**Technical Information
Version Update**

June 15, 2005

**JX6-CON1 / JX6-CON+ Modifications
from Version 3.001 to Version 3.033**

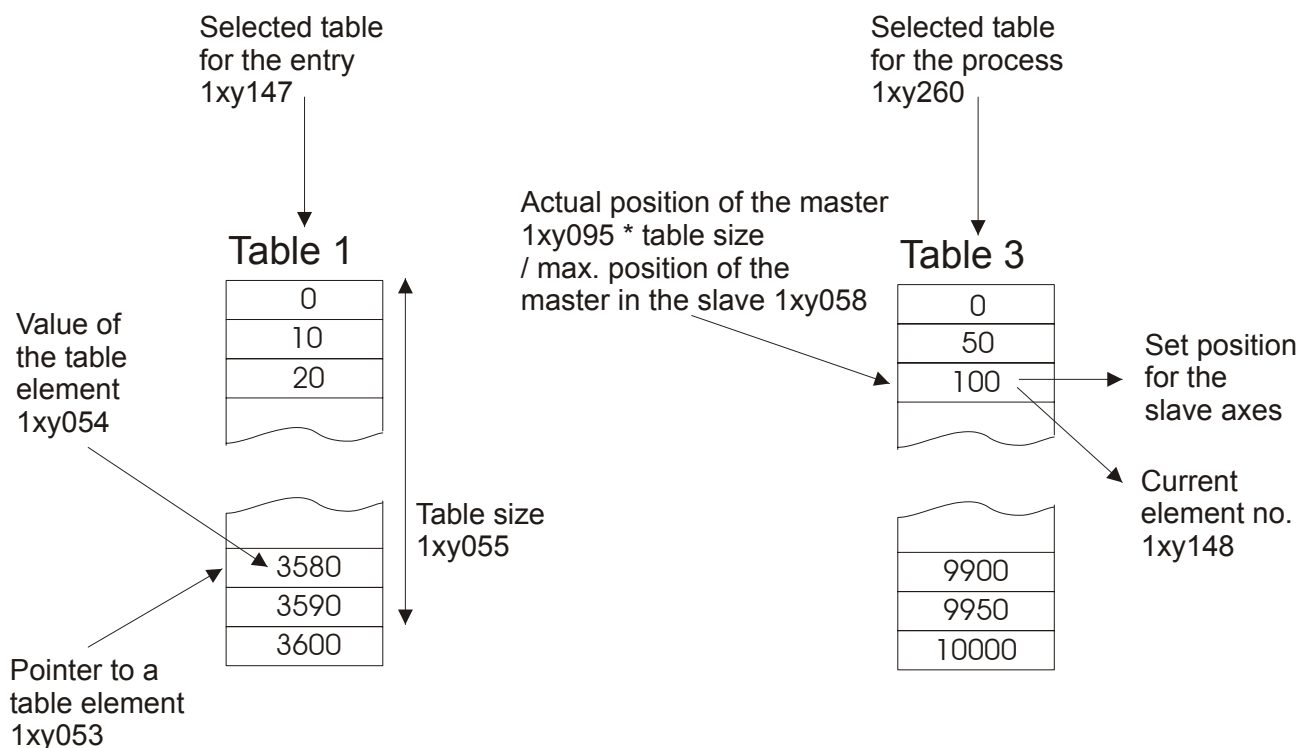
- (3.004) Starting from this version, the tables can be entered and processed separately. This means that it is possible to enter another table while a table is being processed. The new register 1xy260 serves to select the table for the process.

The following diagram illustrates the entry and process of various tables:

As in previous versions, different table sizes are allowed. As long as register 1xy260 is not written, register 1xy147 is used as selected table for the process.

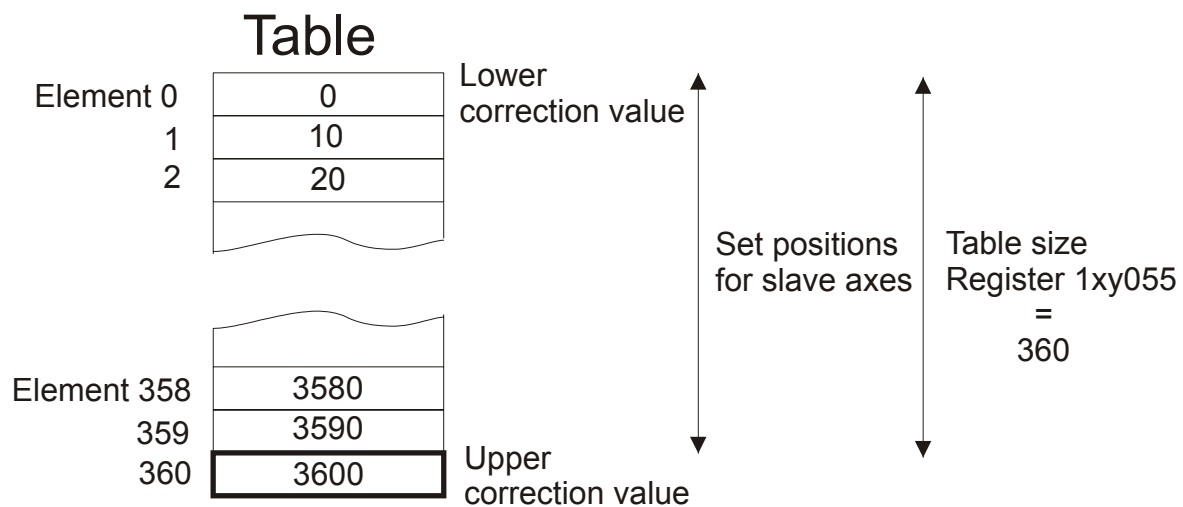
- (3.001) Using the acceleration limitation (register 60) with the follower only worked in one direction.
- (3.002) When recording the actual position in JetSym or Sympas oscilloscope mode, the values might have been incorrect.
- (3.003) Starting from version 2.900, an error might occur when creating a table if a table was written before using a too extensive table pointer.
- (3.004) Starting from version 2.900, the correction value during table mode overflow applied to the last table element. Starting from this version, the correction value must be entered again as additional element:

The correction value in case of table overflow is calculated as follows:

Correction value

= Value of the table element (register 1xy055) – value of the table element (0)
 = 3600 increments – 0 increments = 3600 increments
